STATE OF NORTH CAROLINA  
DEPARTMENT OF TRANSPORTATION

November 04, 2020

Subject: **Request for Modification to Individual Section 404 and Section 401 Water Quality Certification** for the Winston-Salem Northern Beltway from US 52 to US 311 (New Walkertown Road), Forsyth County. Federal Aid Project No. NHP-0074(213), TIP Nos. U-2579D, E& F. Division 9.

**UT to Mill Creek and Mill Creek  
On-site Stream Mitigation Feasibility Report for  
Winston-Salem Northern Beltway  
Forsyth County, North Carolina**

**Figure 1**

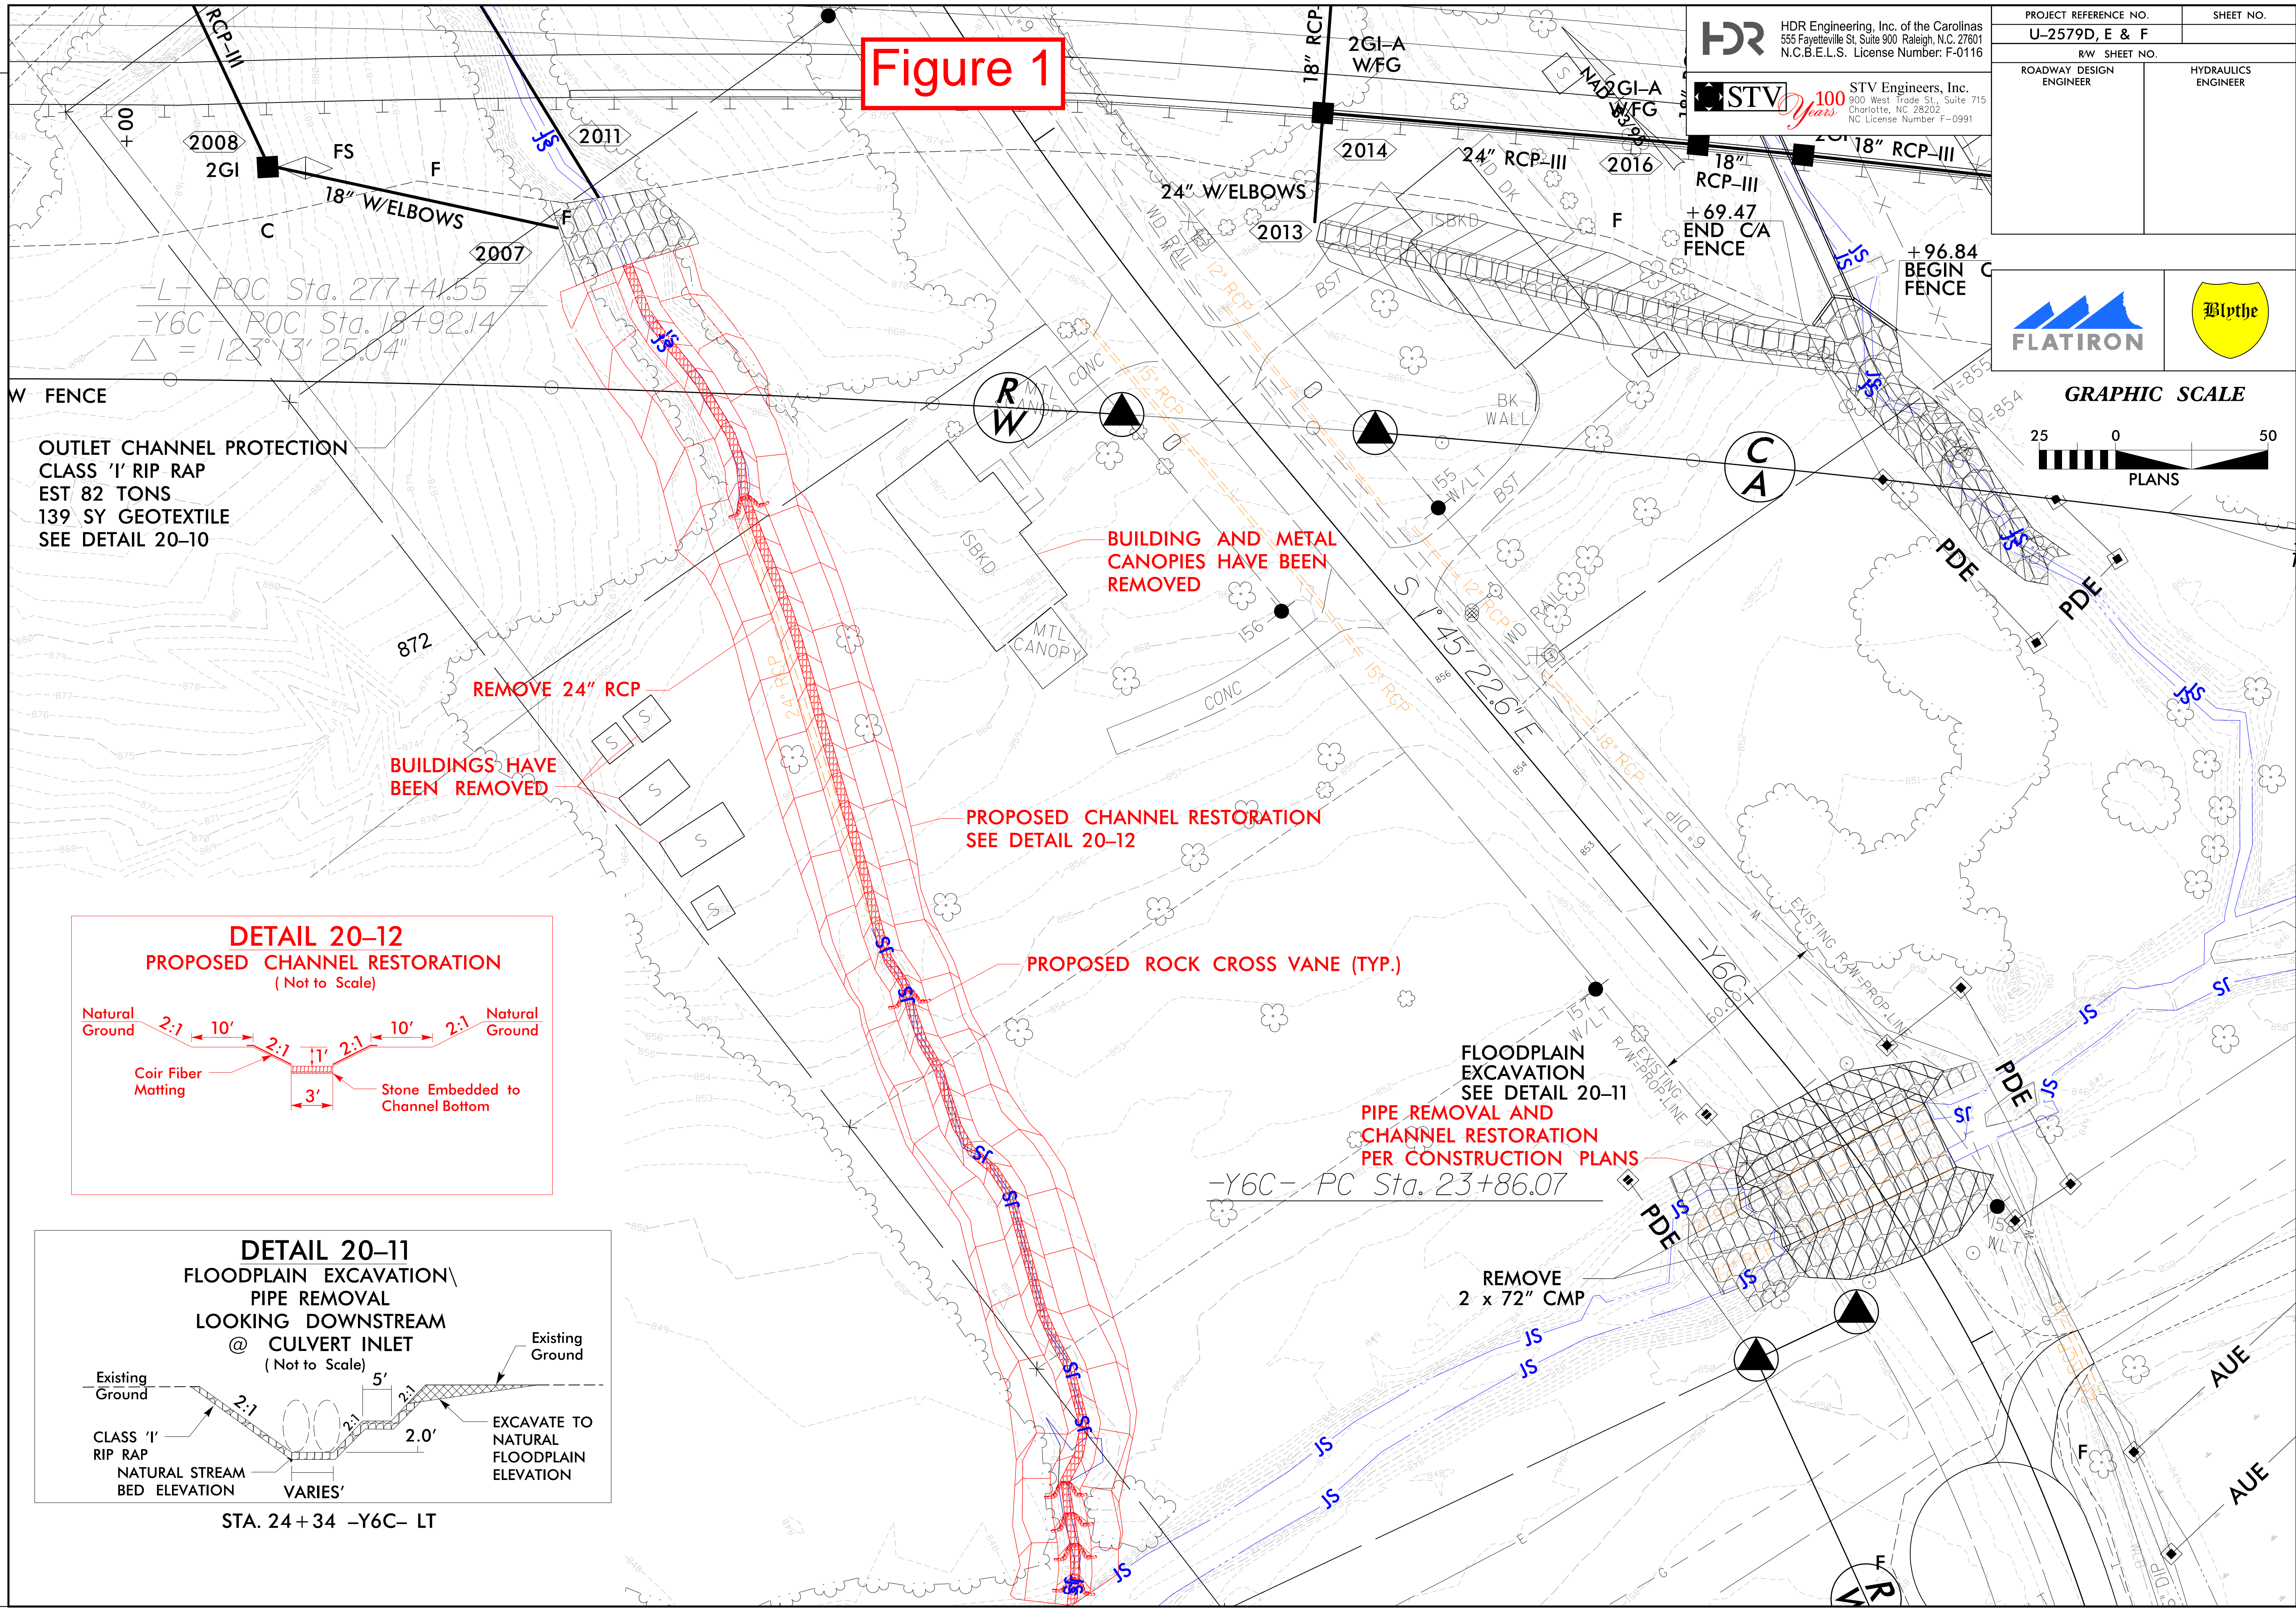
- Option 1a proposes to remove 141 ft of existing 24" pipe and Provide full restoration of the UT to Mill Creek by grading a new floodplain, installing a number of grade control structures and steps to stabilize the channel, and plantings. See Figures 1 thru 3.

Grade control structures would be needed for stability of the channel and prevention of potential head-cutting in the channel. In addition, the new channel will need to be steeper than existing pipe to avoid drastic elevation changes at the upstream and downstream ends. As seen in profile drawings for Options 1a and 1b (Figures 3 and 6) the longitudinal slopes would need to be 3.5-4% to better tie with the channel upstream and limit amount of grade change at the downstream end. Grade control needs to be achieved through the use of rock cross vanes. These have been shown on the mitigation plan drawings for Options 1a and 1b (Figures 1 and 4).

Figure 6

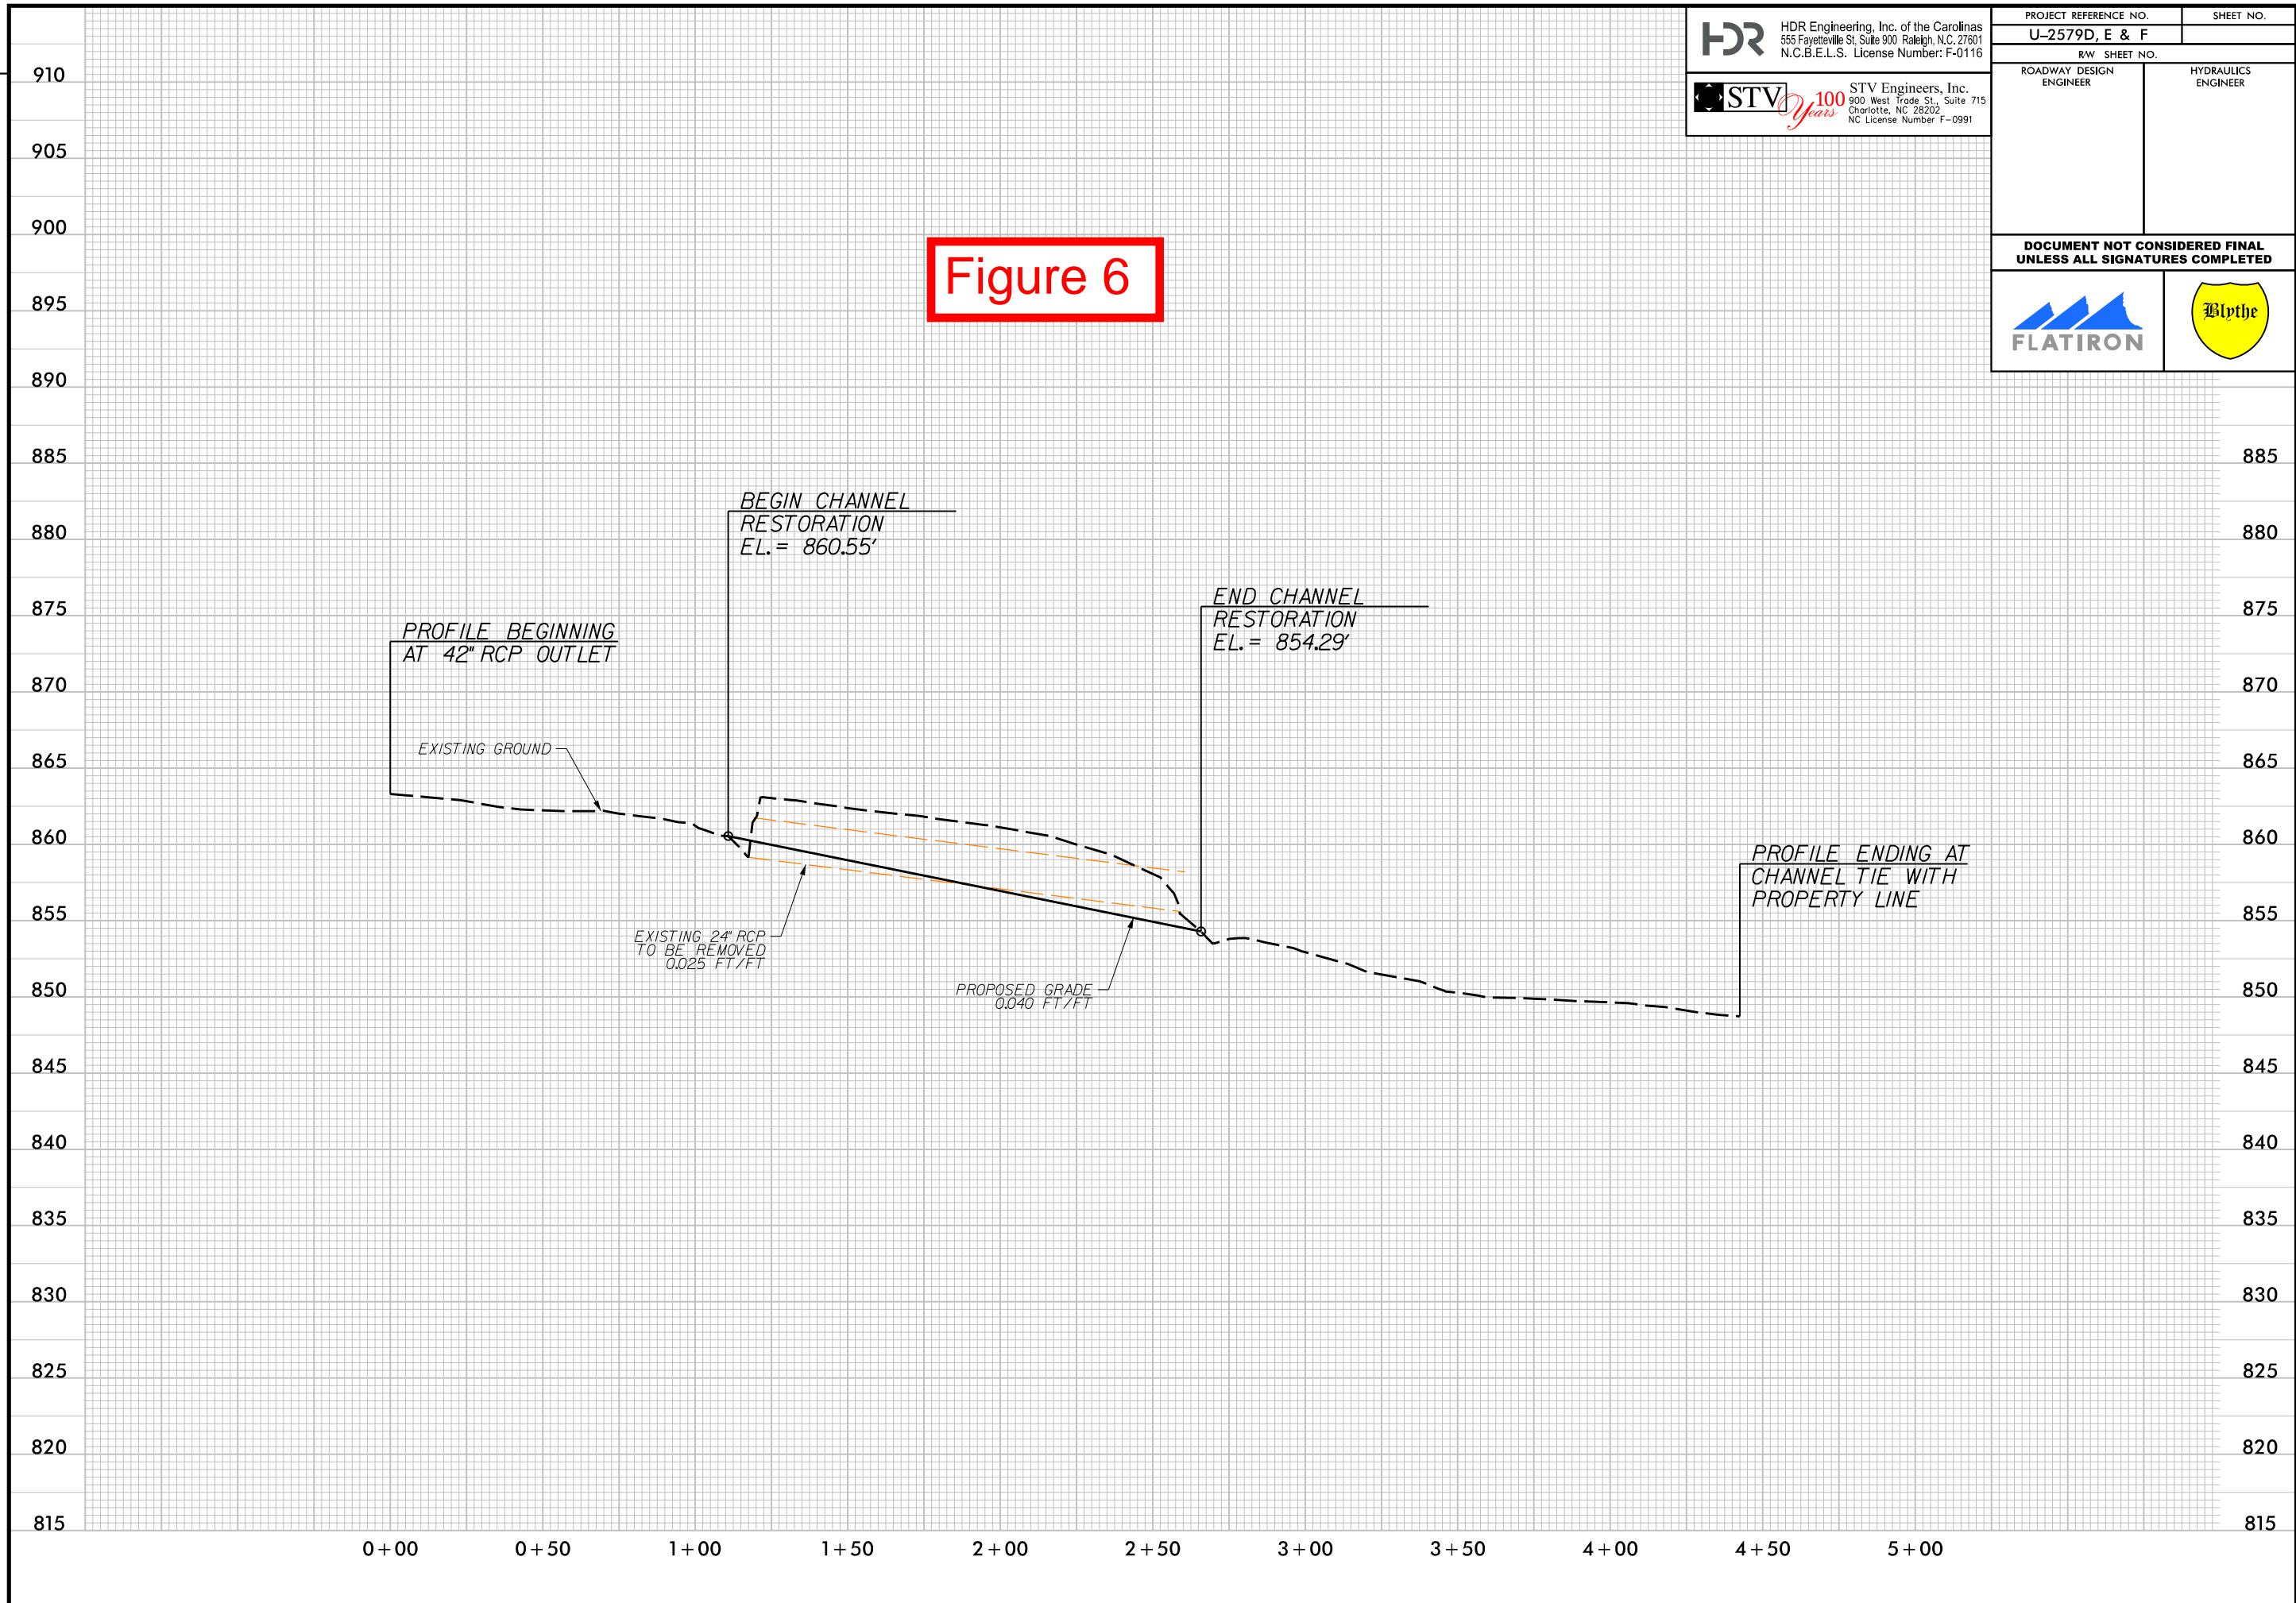
The existing 24” pipe to be removed has a slope of 2.5%. As shown in the profile drawing (Figure 6), there is notable drop-down in channel elevation as water enters the inlet side of the pipe. At the outlet end there is a 2’ drop from pipe outlet to channel bottom. This outlet drop is stabilized by a small concrete pad.
